Detailed Site Plan (Amendment) DSP-2026-0004

Capital Plaza Eastern Pad Site

STAFF REPORT

SUBJECT: Detailed Site Plan (Amendment) DSP-2026-0004
Capital Plaza Eastern Pad Site

G. L. W. FILE No. 01190
SHEET C 4
DSP SHEET 4 OF 48

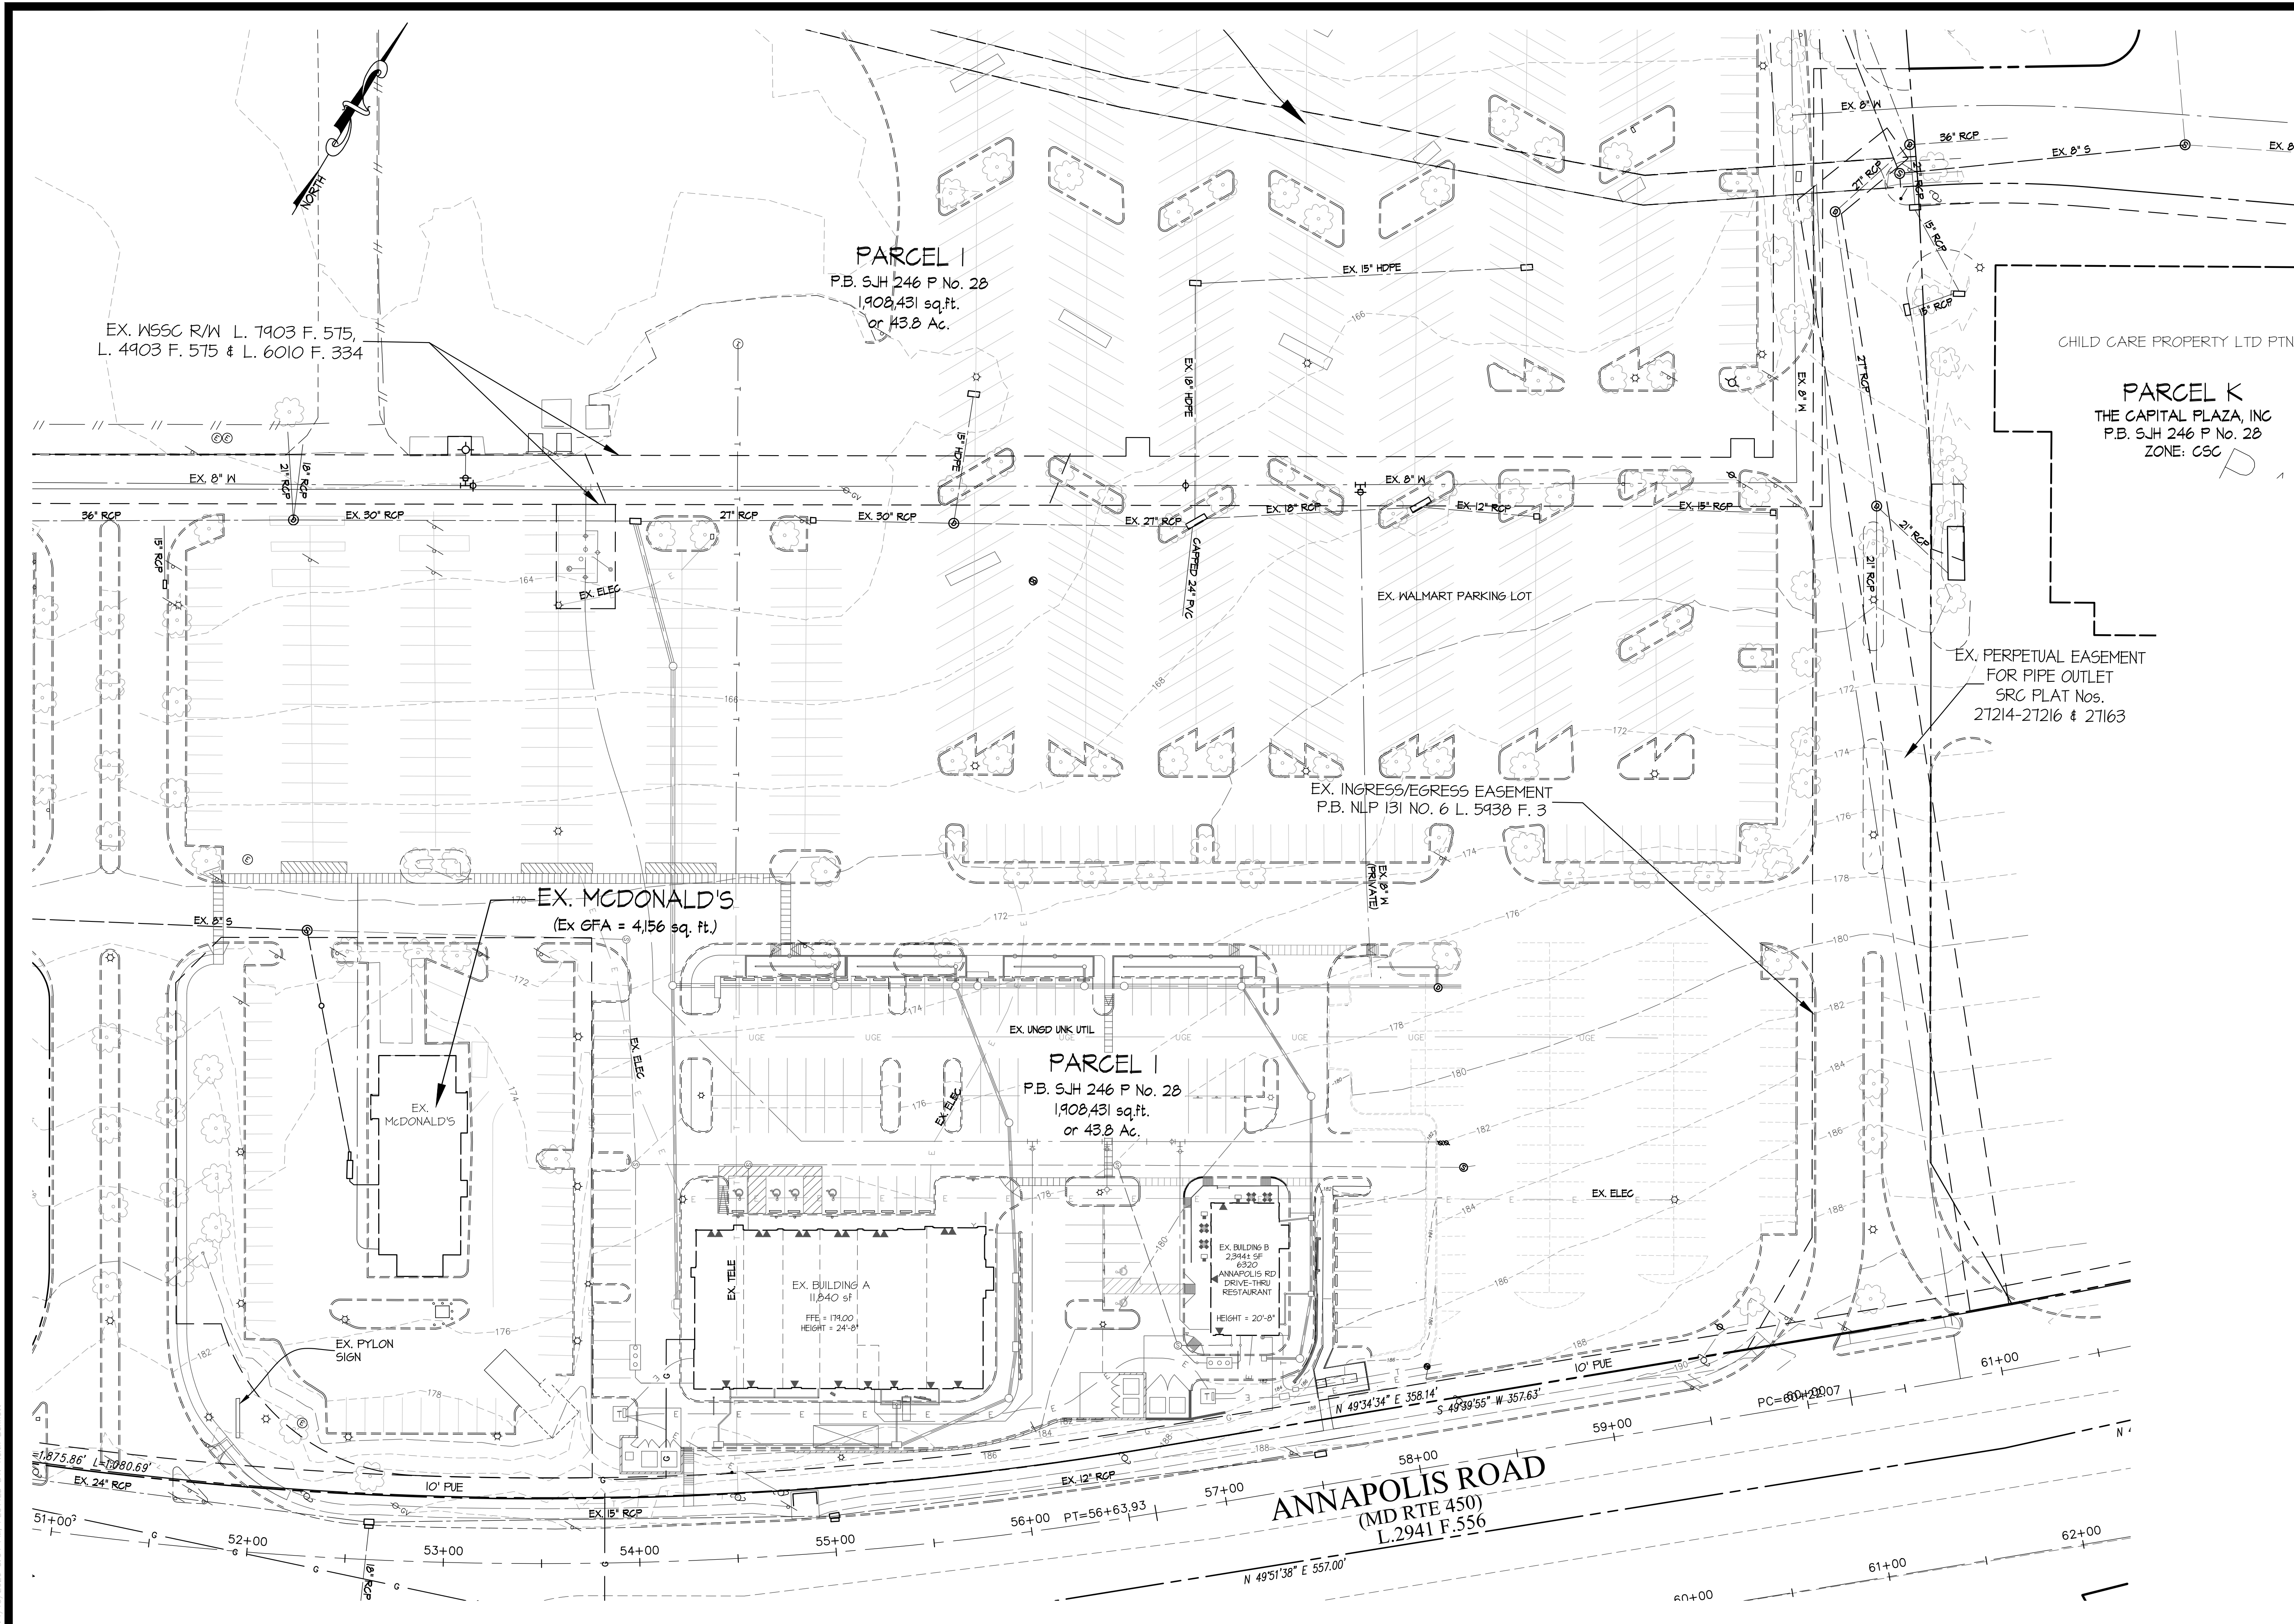
a. The applicant shall correct the spelling of "Capital" in General Note 1.
b. Correct Sheet C-4 to refer to the subject project consistently as DSP-15020-03.
